SOUTHWEST BIKEPATH CULVERT REPLACEMENT AT WAITE CIRCLE - 2019

CITY OF MADISON, WI

CITY PROJECT NO. 8466

ADDENDUM 1
8/29/19
CHANGED ENTIRE
DRAWING

GENERAL PROJECT OVERVIEW & SURVEY CONTROL

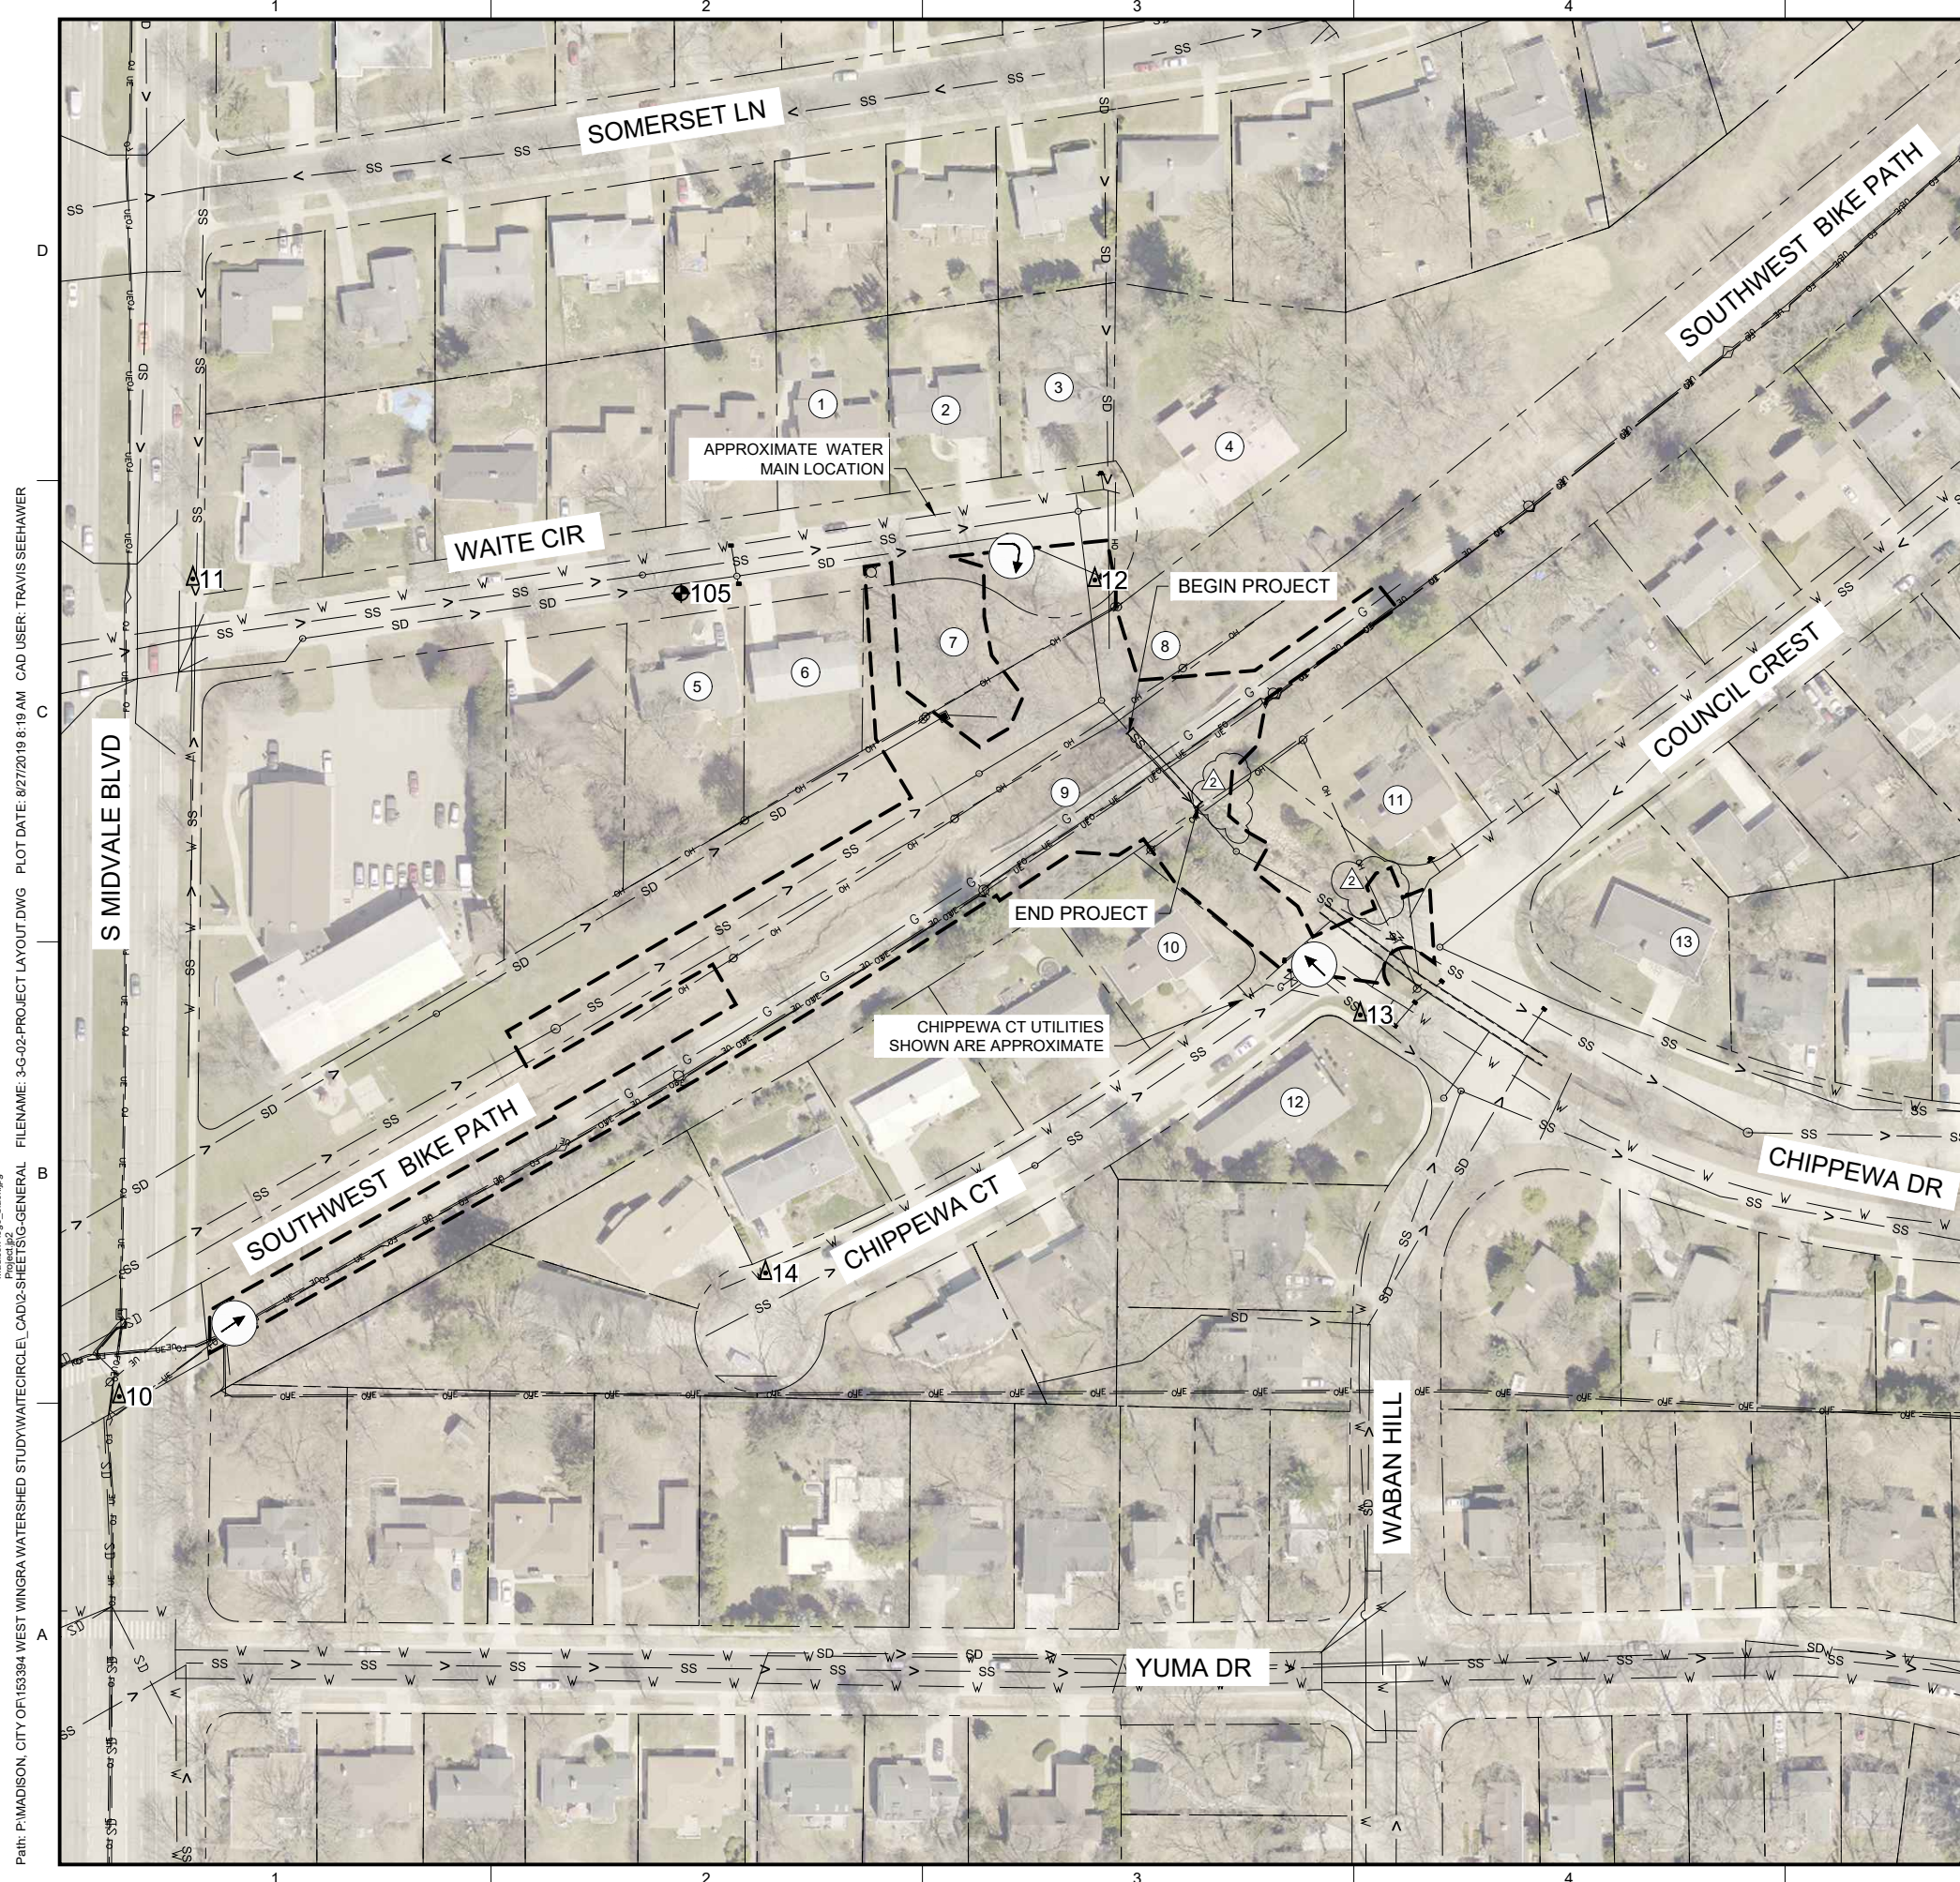
**ADDENDUM 1
CHANGED
CONSTRUCTION
LIMITS**

**EROSION CONTROL
PLAN**

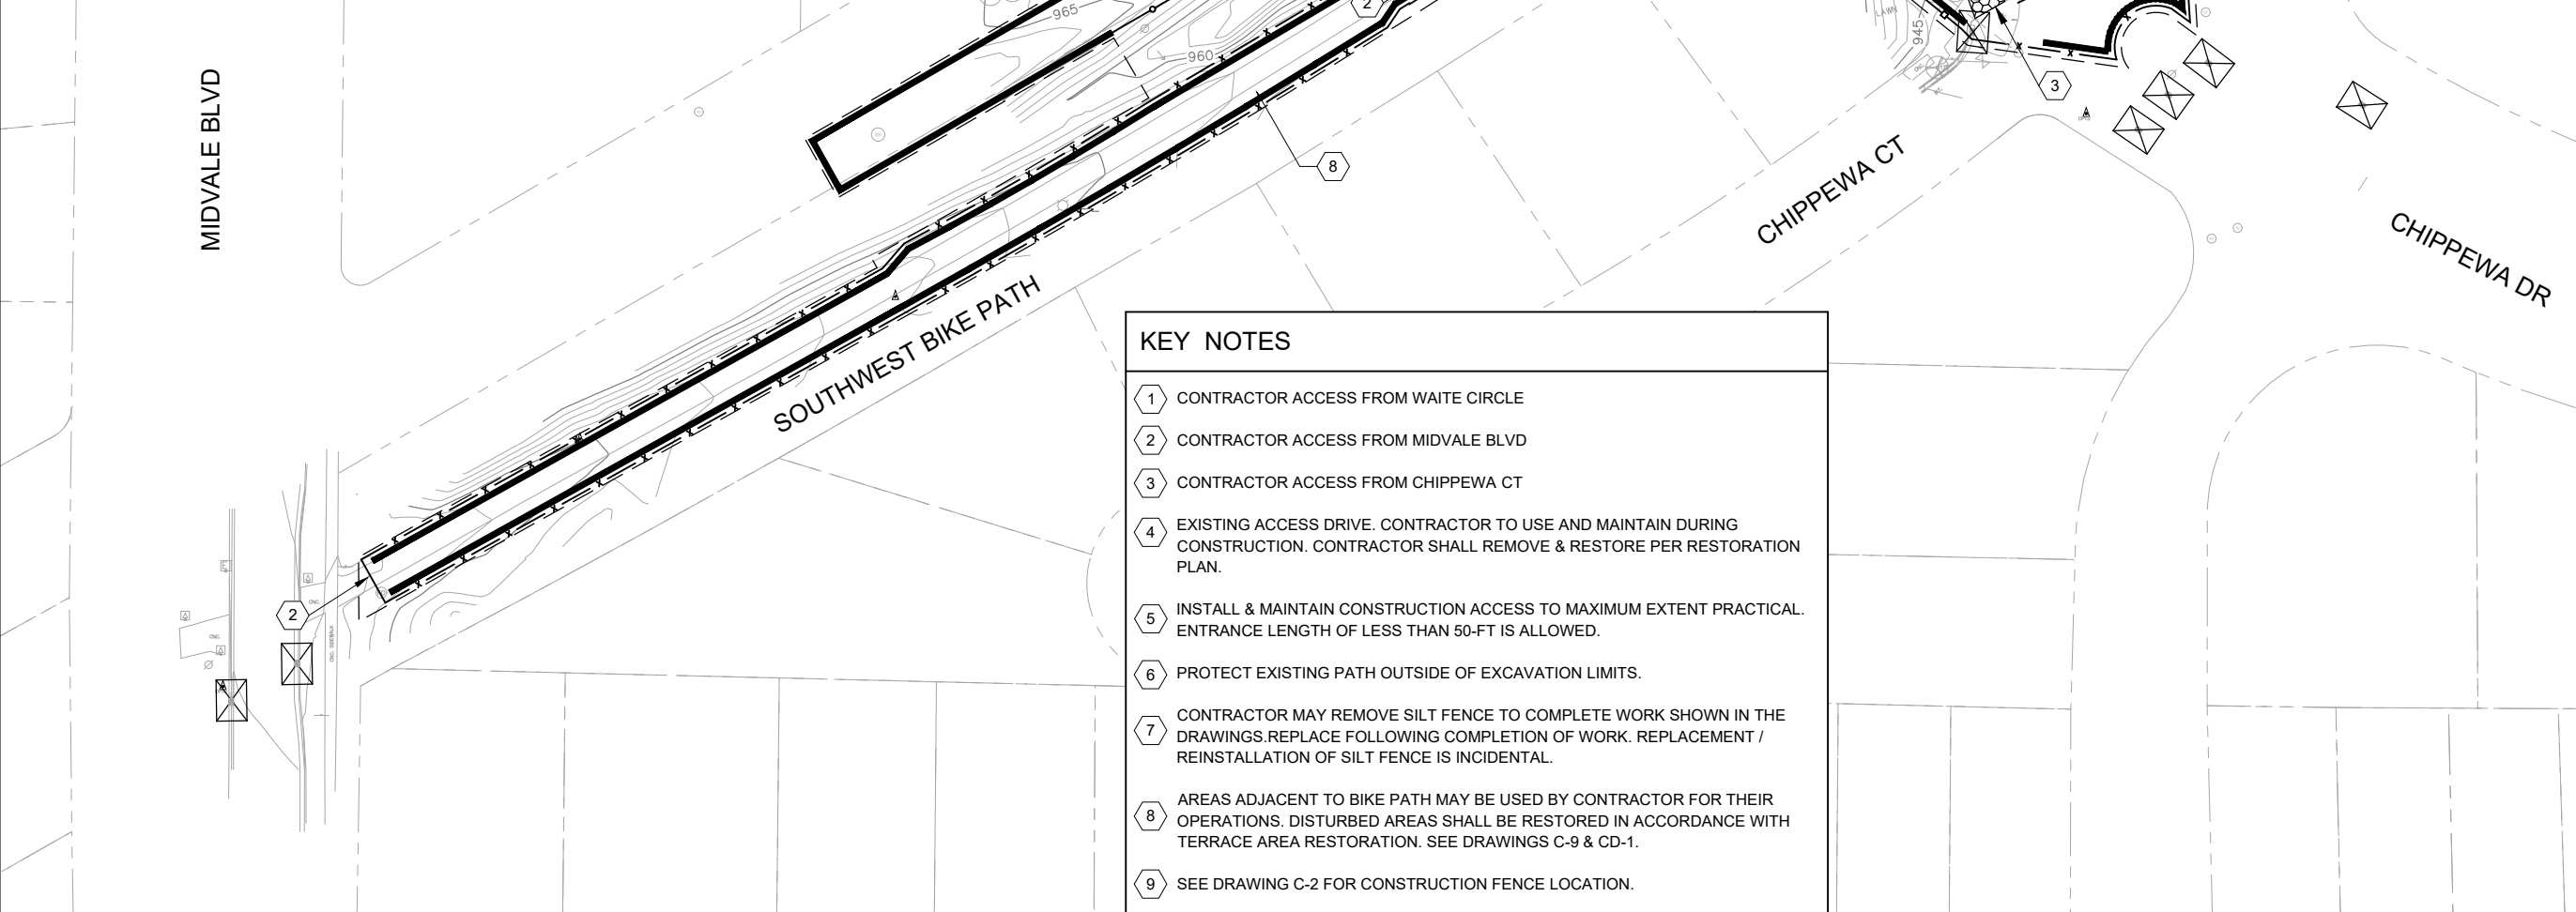
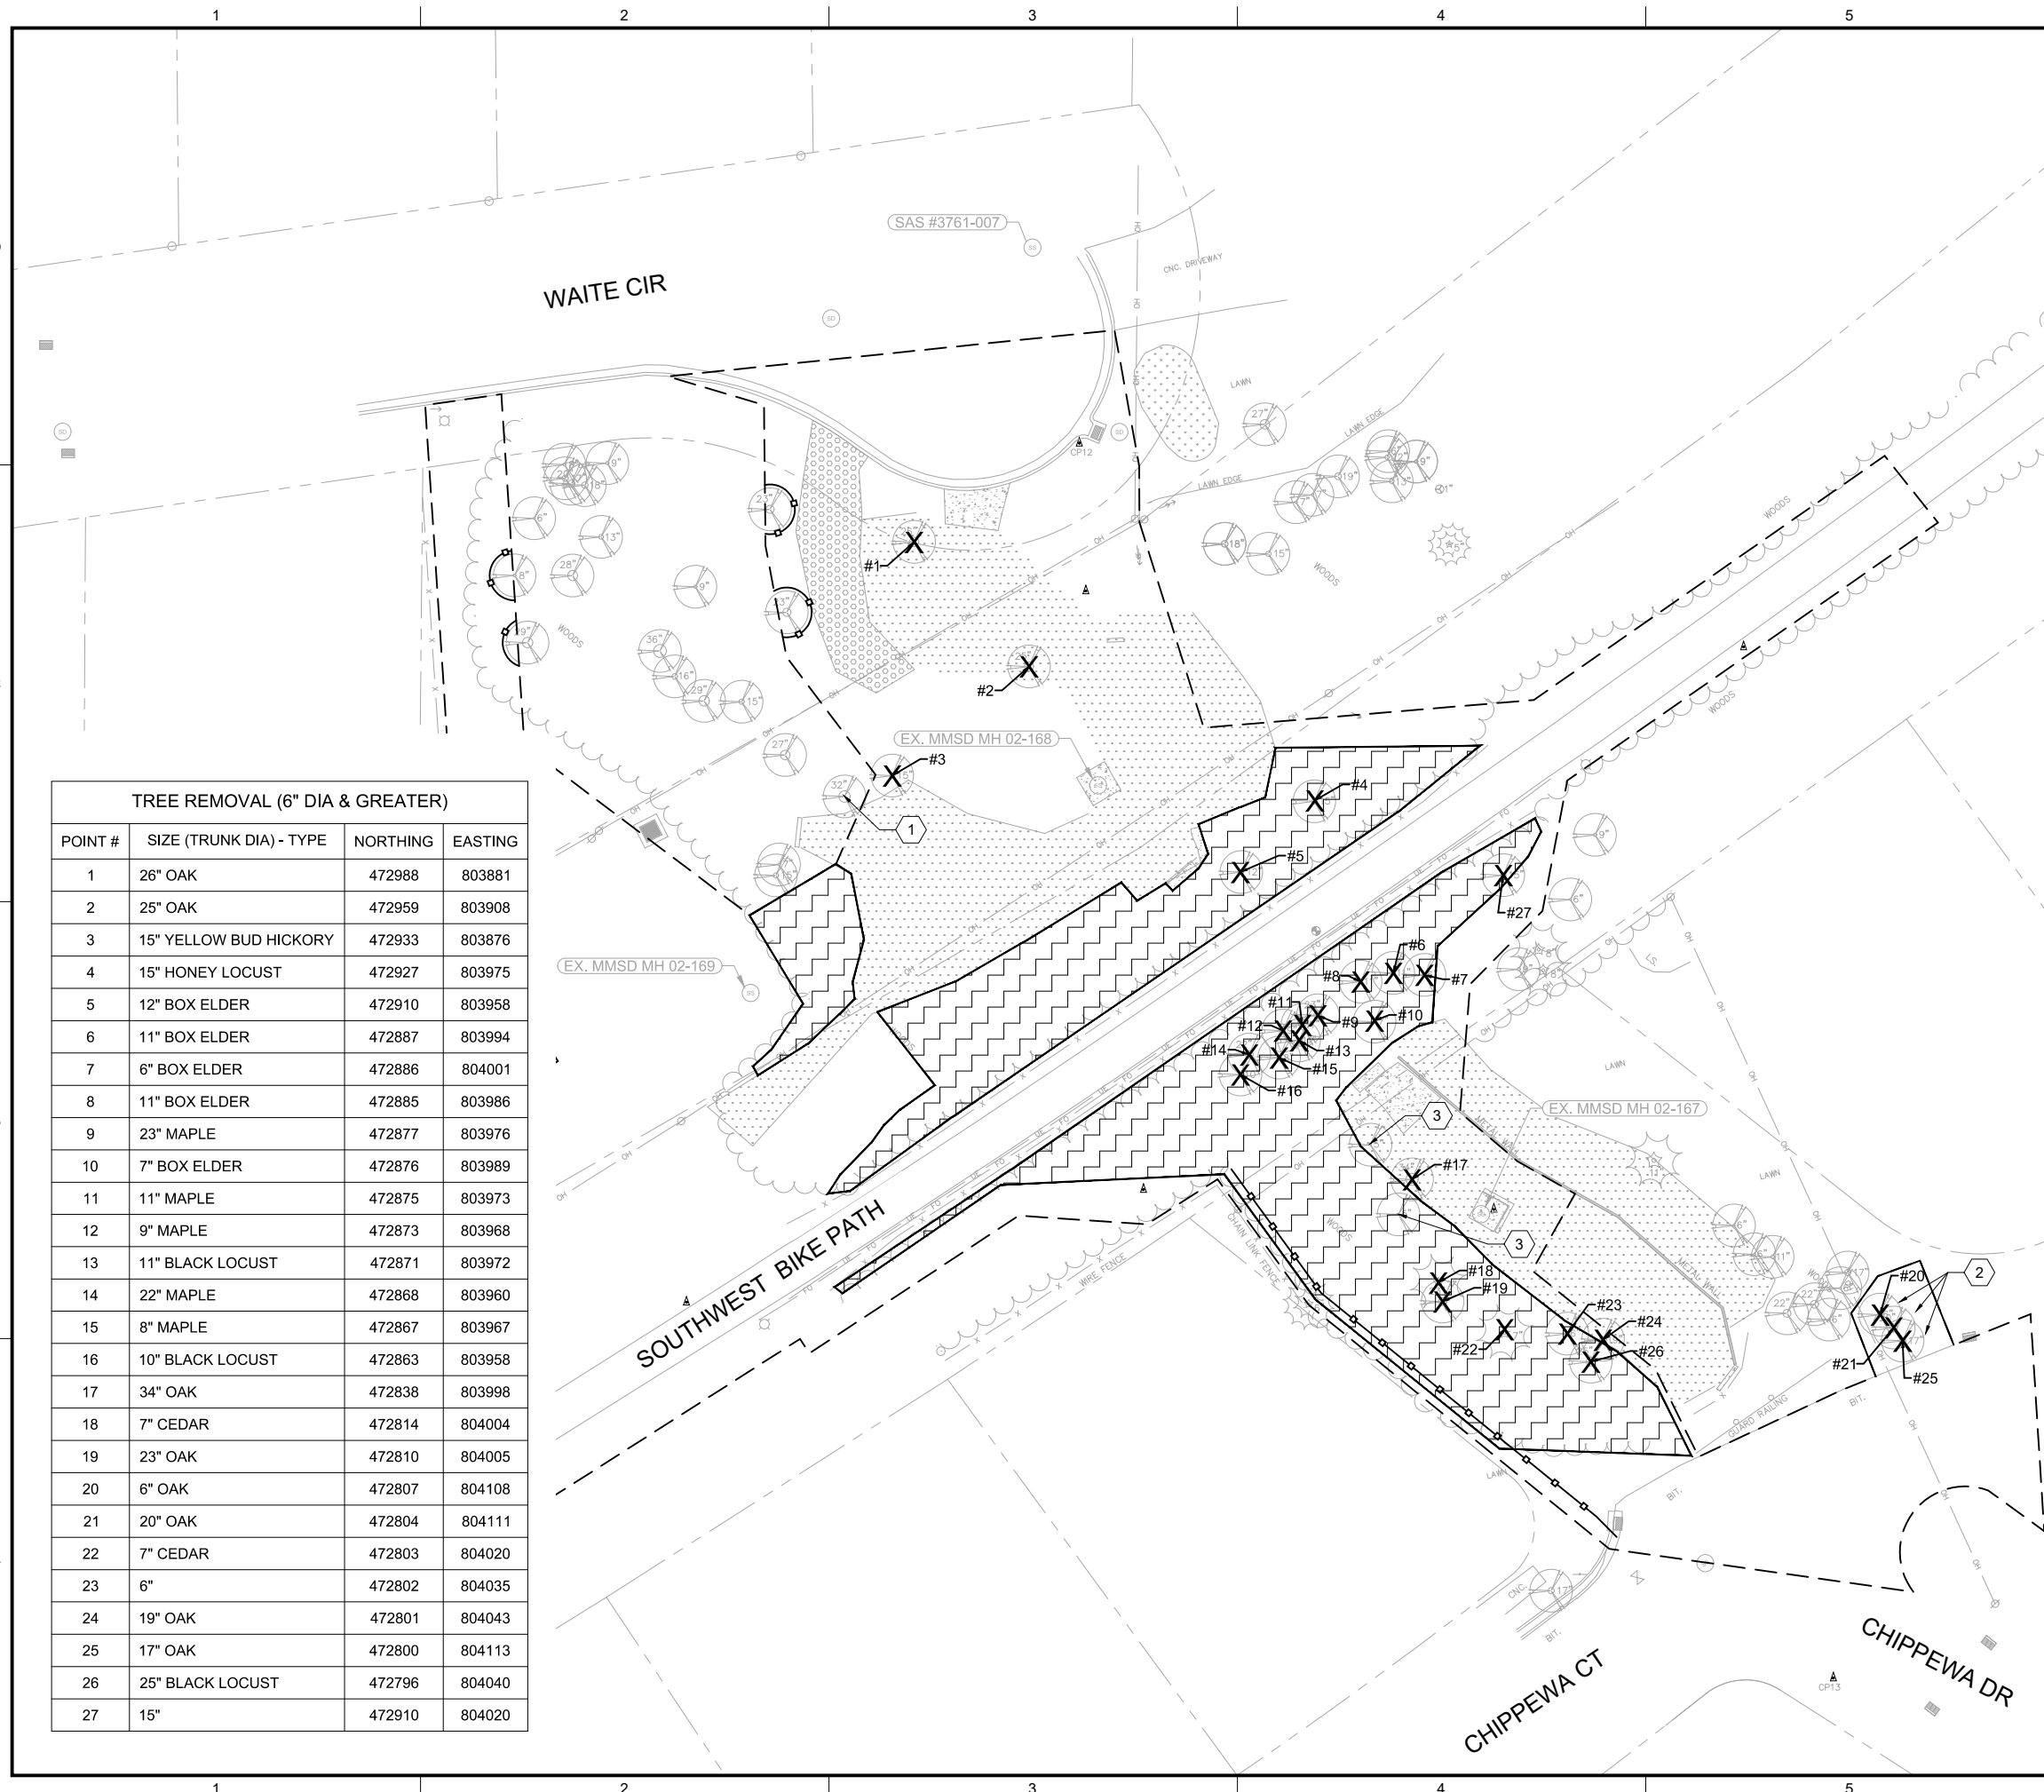
**ADDENDUM 1
CHANGED
ENTIRE
DRAWING**
